CS Memorandum No. 1325

Subject: Configuration Management Board Meeting No. 106

CMB Meeting Minutes #106

REFERENCE: Project No. M544.1, Contract No. 149 Task 1-8.02
Final Design

\\Sofra003\ym6441\Final\Design\Drawing-821\2-Civil\Utility Demolition\Sheet Files CP03\M54423\UD402.dwg FBoyant Wed Jan 26, 2011 1:57 pm UD-402

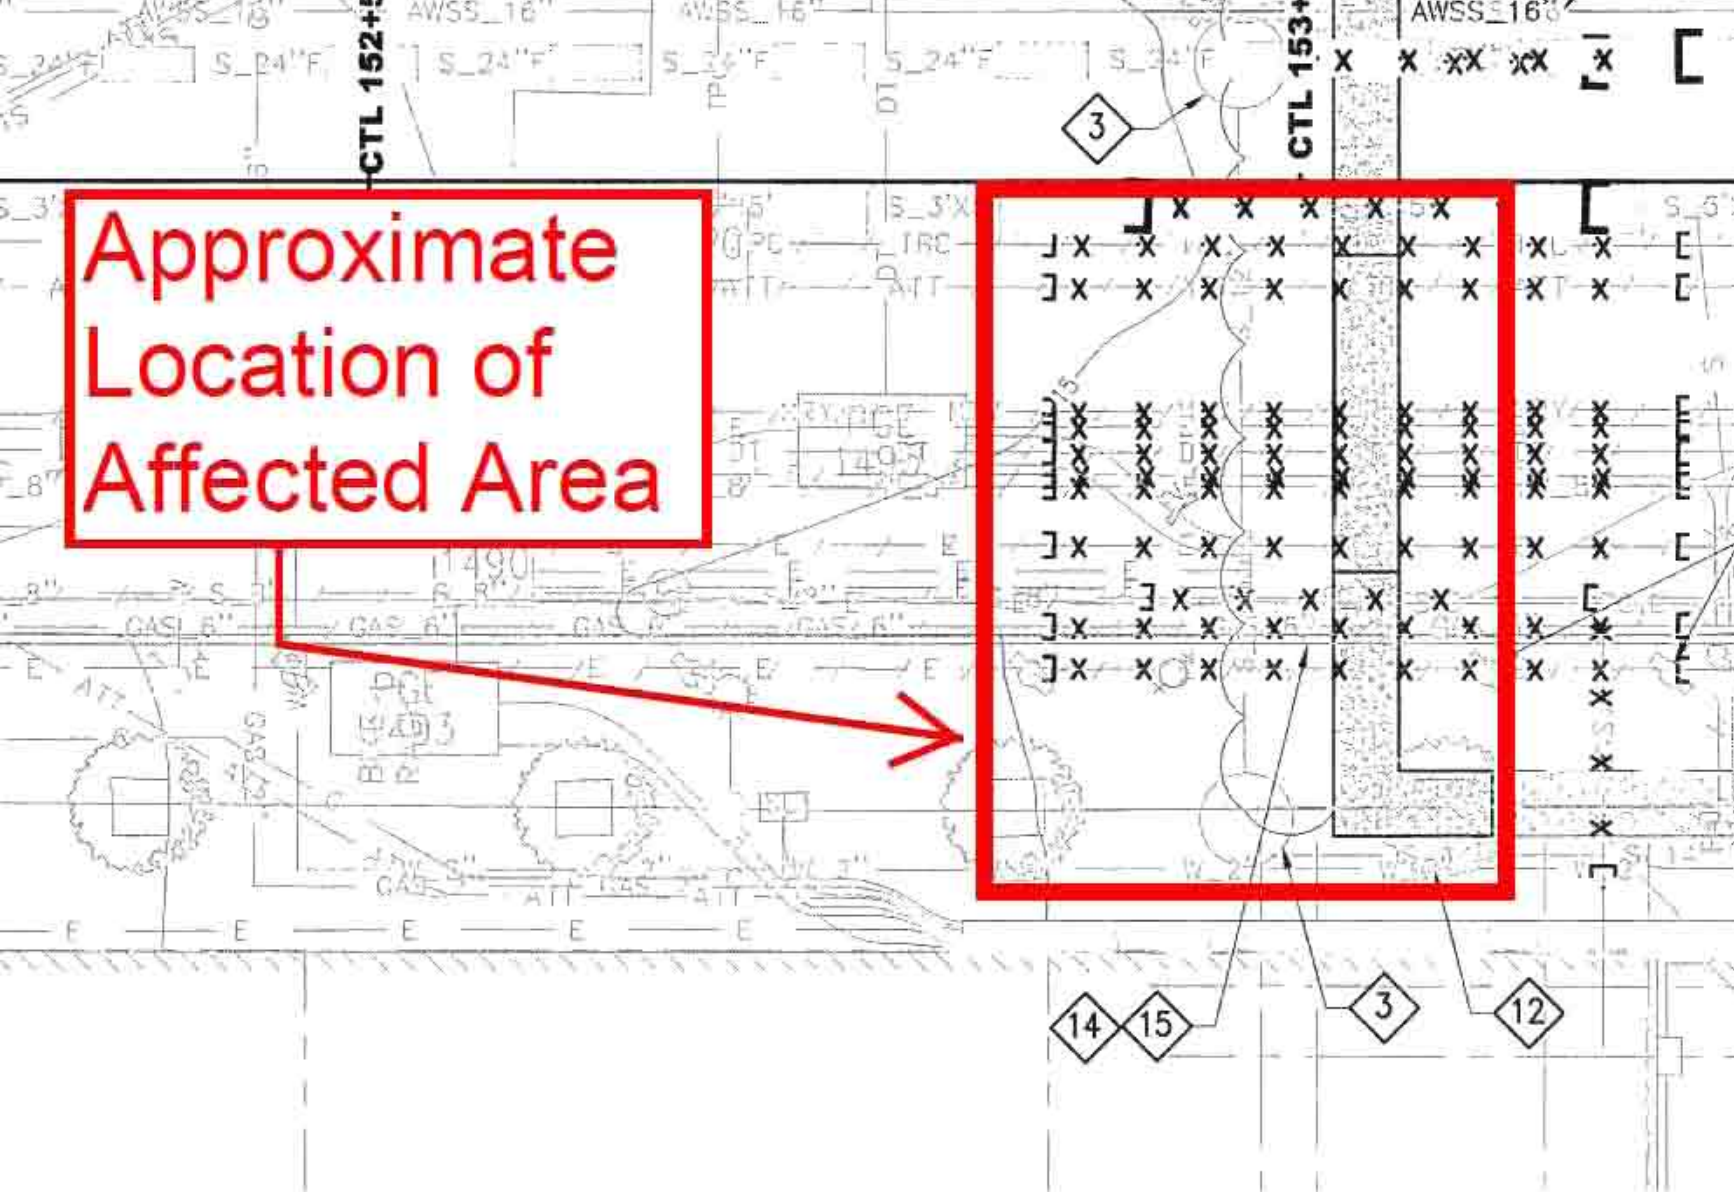
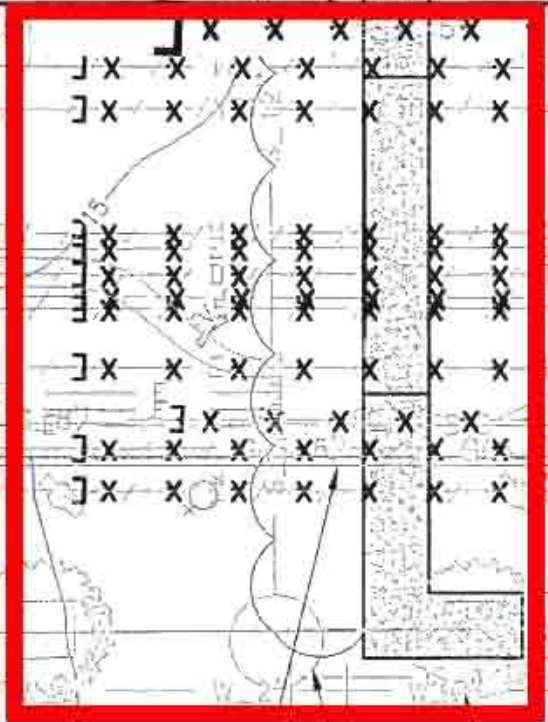
Recommendation: Accept justification of Merit for COR 012 - Archaeological impacts at the Moscone north headwall.

Facts: On July 2nd, 2012, while excavating for guidewalls at the Moscone north headwall the Contractor discovered archaeological artifacts within the excavation area. The Contractor immediately notified the Engineer. The Program's Archaeologist, with concurrence of the Environmental Review Officer (ERO), implemented a modified process based on the Archaeological Testing Plan (ATP) for Moscone Station, to specifically address trenching conditions. The modified process involved bagging midden, moving to available area at the work site so that guidewall excavation could continue, screening a sample of the midden at site, confirming no new or additional artifacts were found, and disposing of midden at the site with other excavation.

Contractor Rationale for COR: The Contractor contends archeological artifacts encountered at the site were a differing condition, as it was not shown on the bid documents. As a result the Contractor provided support for the removal of the materials and claims to have experienced standby to their equipment.

\\s6nos003\m544.1\FinalDesign\Drawing-821\2-Civil\Utility Demolition\Sheet Files CP03\M54423UD403_R1C.dwg fboyani Thu Aug 25, 2011 - 9:21 am UD-403_R1C

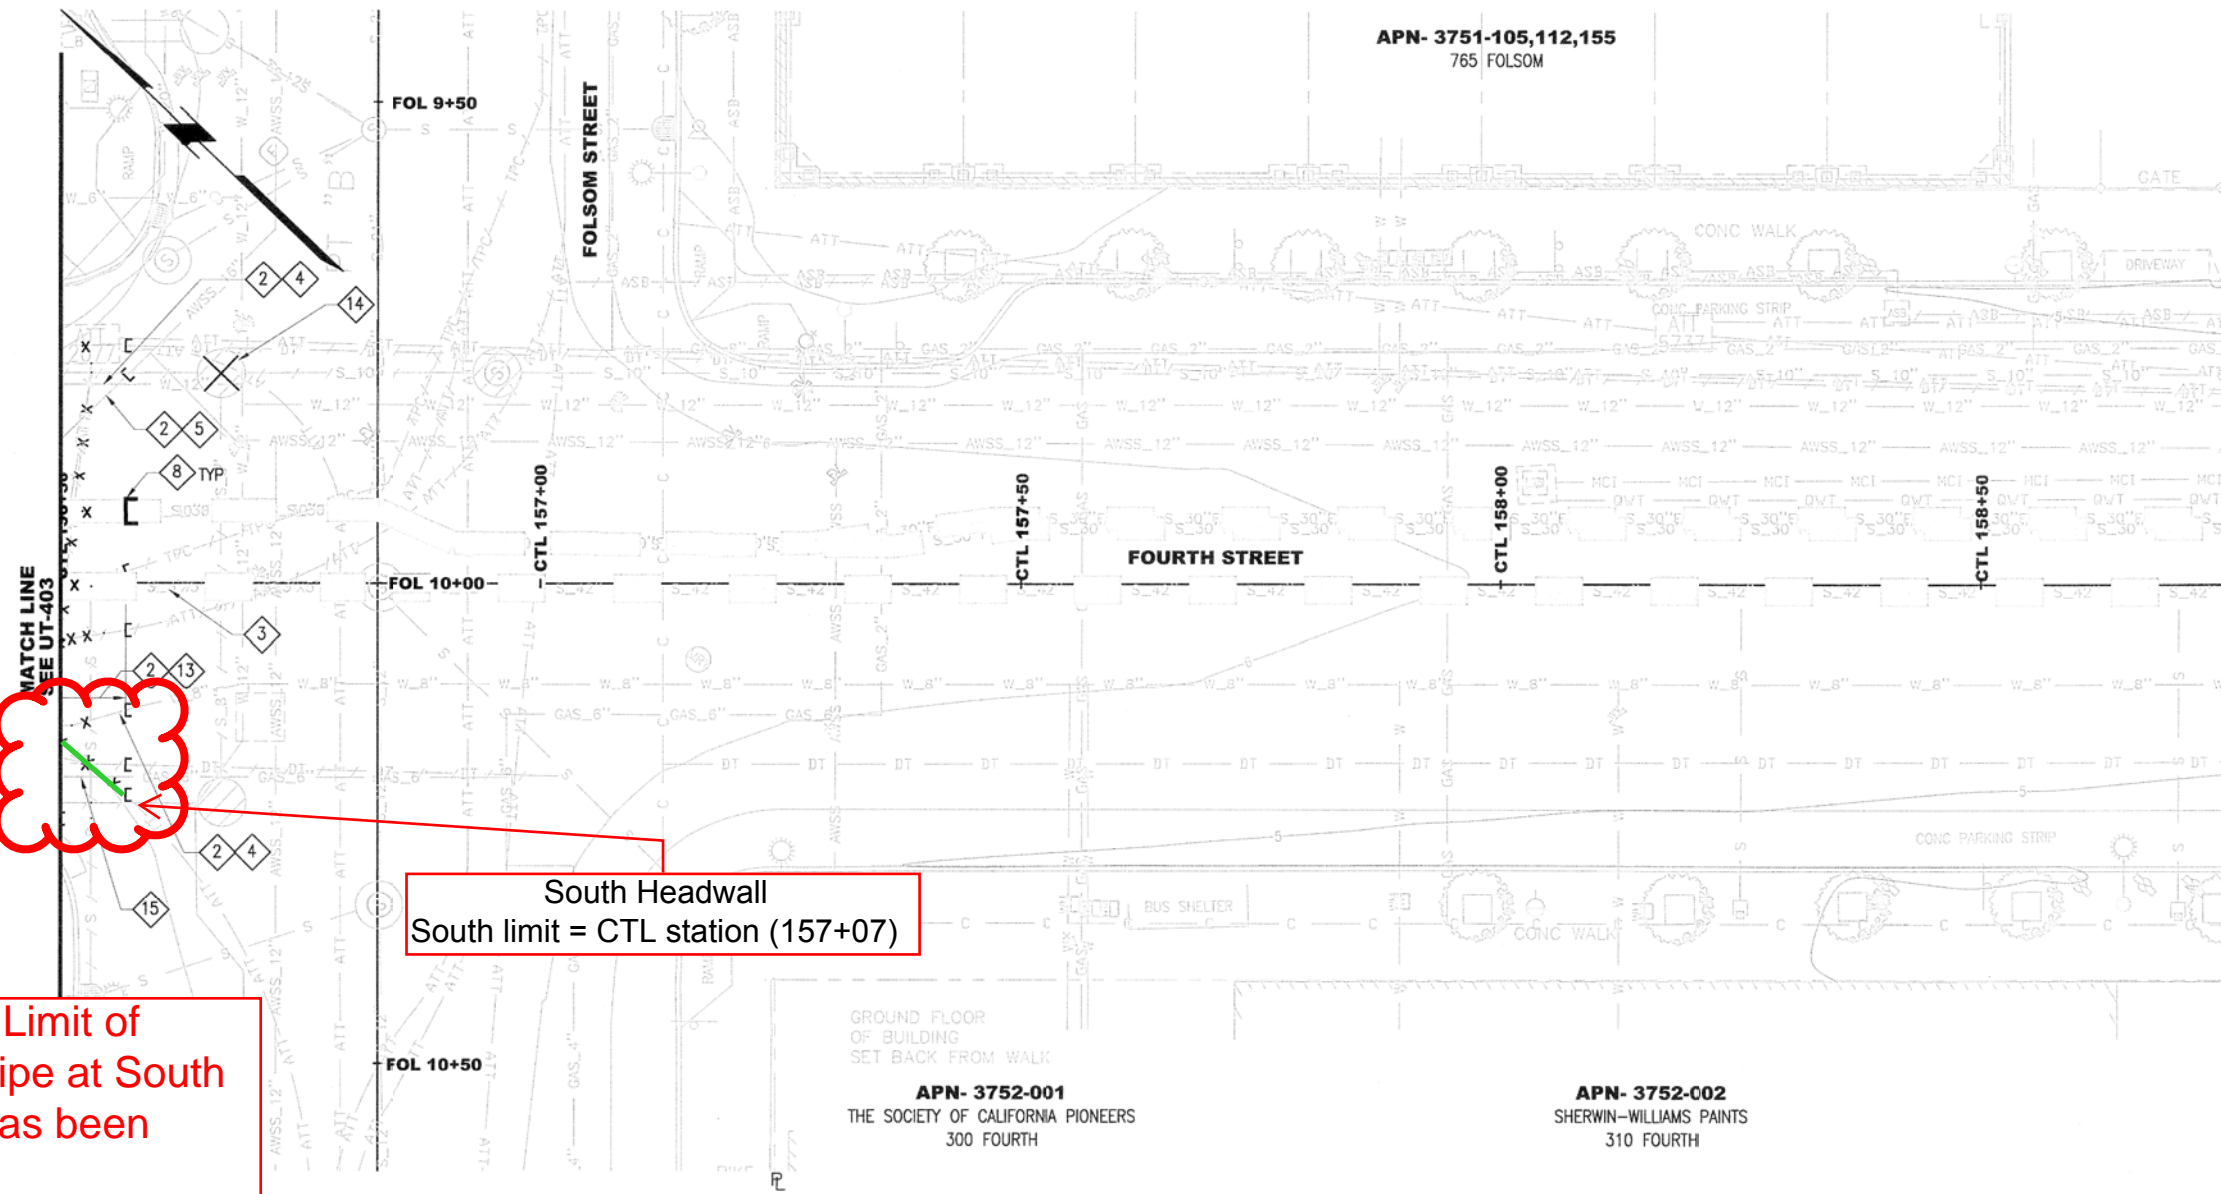
Recommendation: Accept justification of partial Merit for additional costs associated with COR 026 – Moscone Asbestos Pipe Abatement at South Headwall. Costs for removal, abatement and disposal of asbestos laden transite pipe shall be considered for compensation under and in accordance with Bid Item GE-8 - Environmental Mitigation Allowance. Cost for standby or loss of production shall not be considered for compensation.

Facts: The Contractor discovered an asbestos laden transite pipe on 08/06/12 during utility demolition activities at the Moscone South Headwall location on Fourth St. between Howard Avenue and Folsom Street. The AT&T conduit was shown on the contract drawings but was not shown to contain asbestos material. Removal and disposal of the asbestos pipe was completed by 08/15/12. The Contractor did not submit a request for time extension.

COR 026 - Limit of Asbestos pipe at South Headwall has been demo'ed.

Justification: Additional work and costs were incurred by the Contractor to handle and dispose of the asbestos laden pipe. In accordance with technical specifications section 01-20-00 an allowance has been established to pay for Environmental Mitigation as needed and directed by the City. Standby or loss of production time is not justified because the Contractor was required to locate and identify the underground utilities in advance of the utility removal work.

\\sv6nas003\ms544.1\FinalDesign\Drawing-821\2-Civil\Utility Demolition\Sheet Files CP03\M54423UD4\447 Bayou Wed Jan 26, 2011 - 2:26 pm UD-404

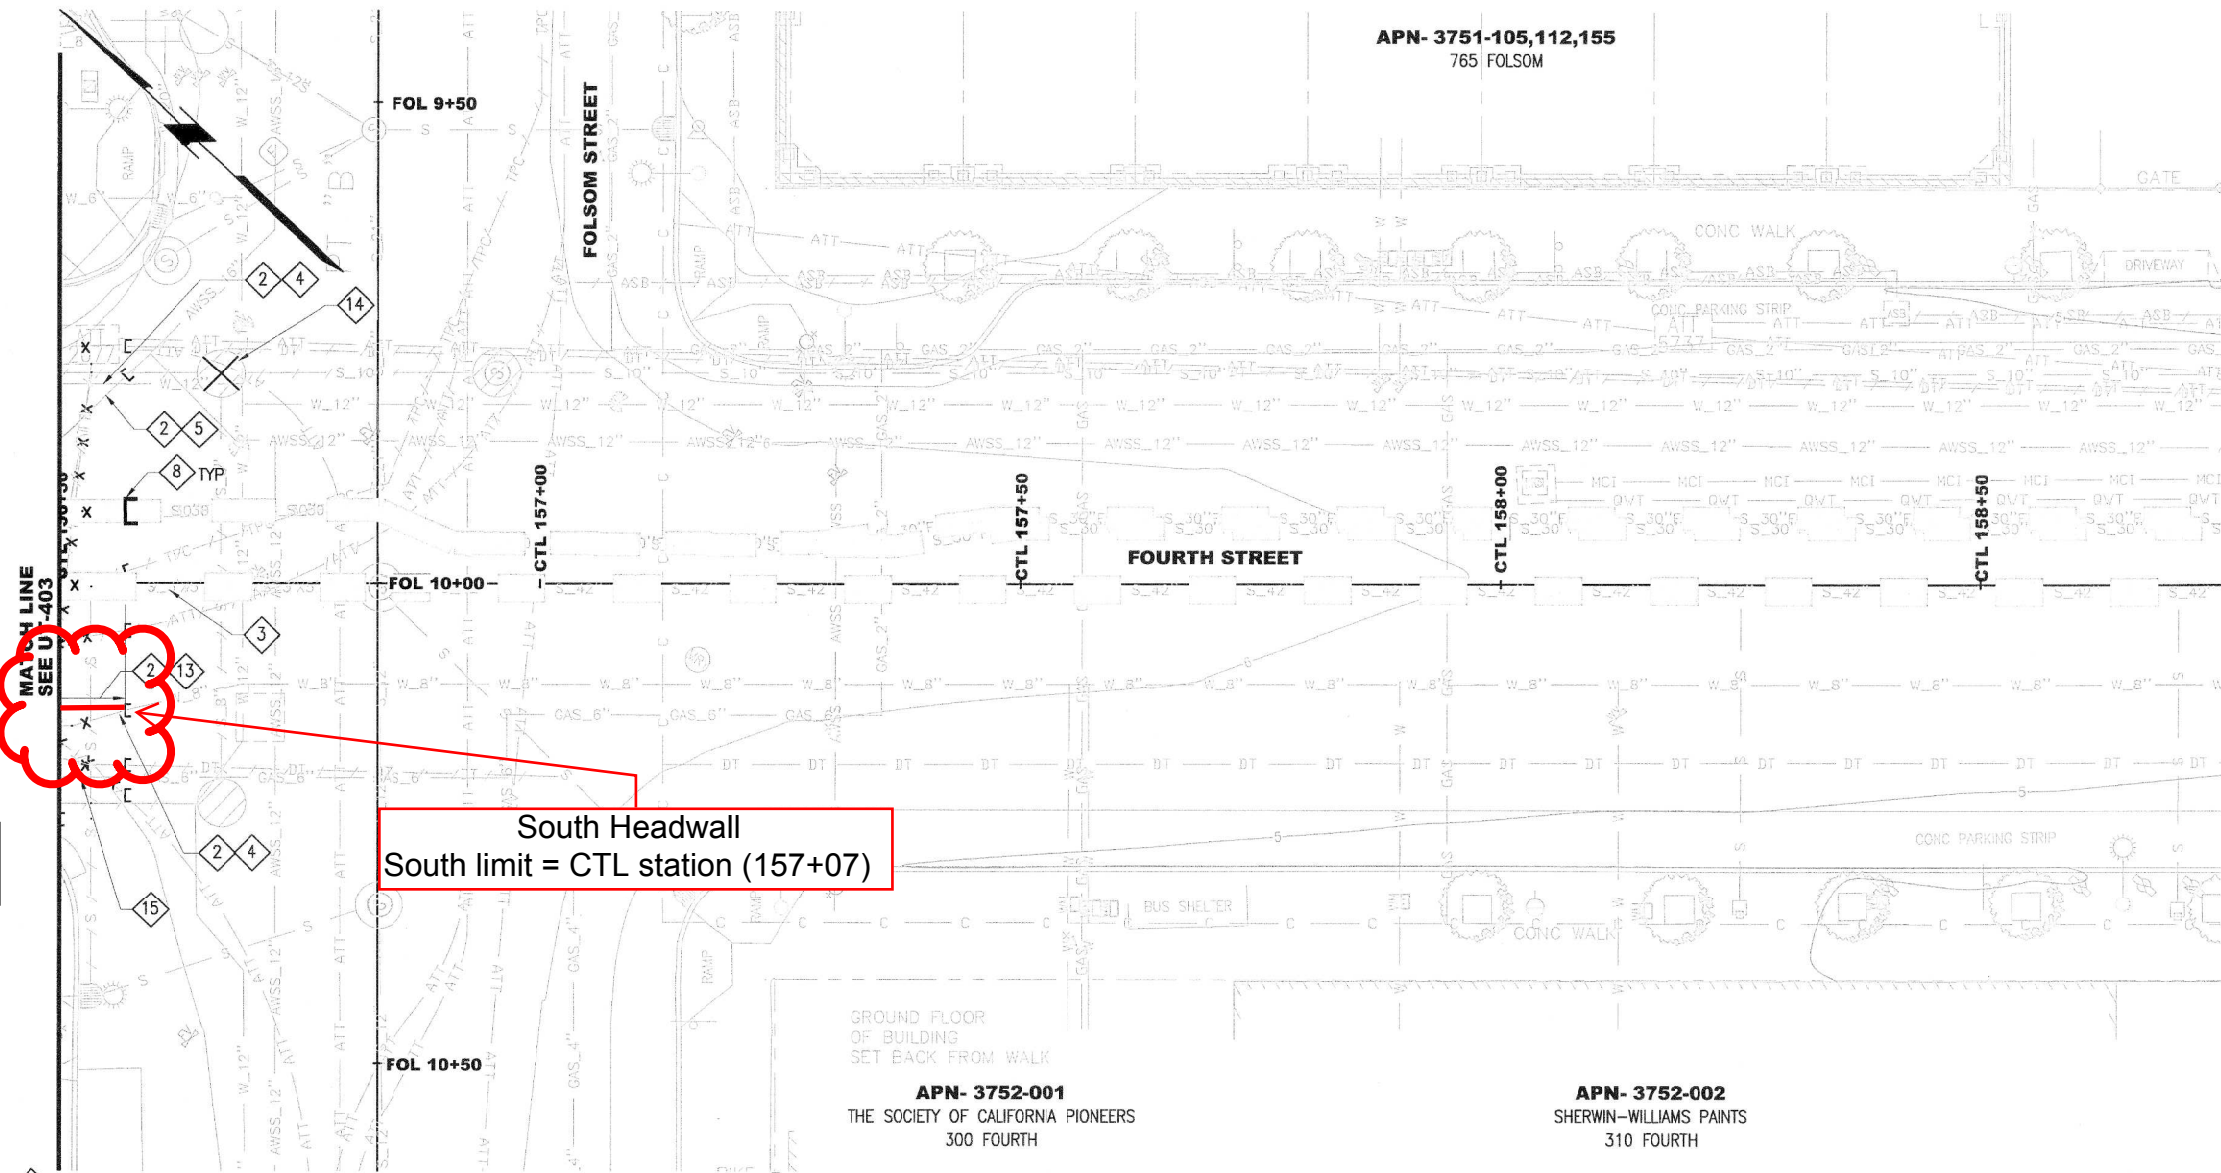
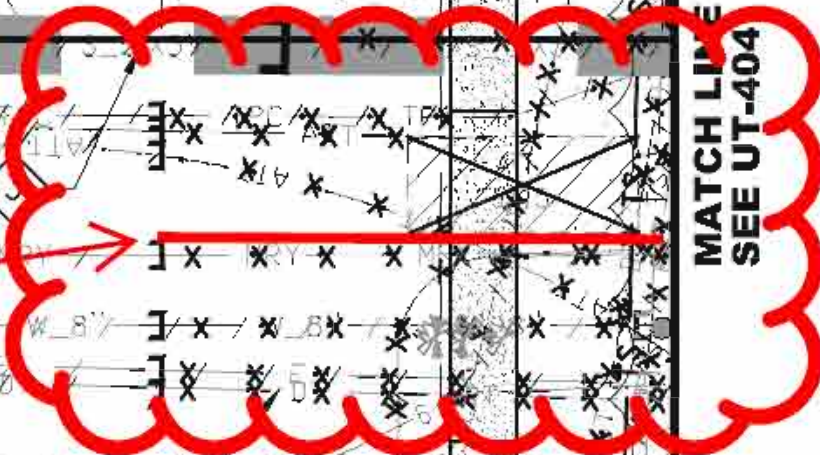
Recommendation: Accept justification of Merit for the costs associated with COR 027 - Moscone - Oil Filled Pipe at South Headwall. Costs for the removal, abatement and disposal of the oil filled pipe shall be considered for compensation under and in accordance with Bid Item GE-8 - Environmental Mitigation Allowance.

Facts: The Contractor discovered a six inch diameter oil filled pipe during utility demolition activities at the Moscone South Headwall location on Fourth St. between Howard Avenue and Folsom Street. The pipe was not shown on the contract drawings. The Contractor completed removal and disposal of the pipe on 08/17/12. The Contractor did not submit a request for time extension for this work.

Oil filled pipe removed at MOS

Justification: Additional work and costs were incurred by the Contractor to handle and dispose of the oil filled pipe. In accordance with technical specifications section 01-20-00 an allowance has been established to pay for Environmental Mitigation as needed and directed by the City.
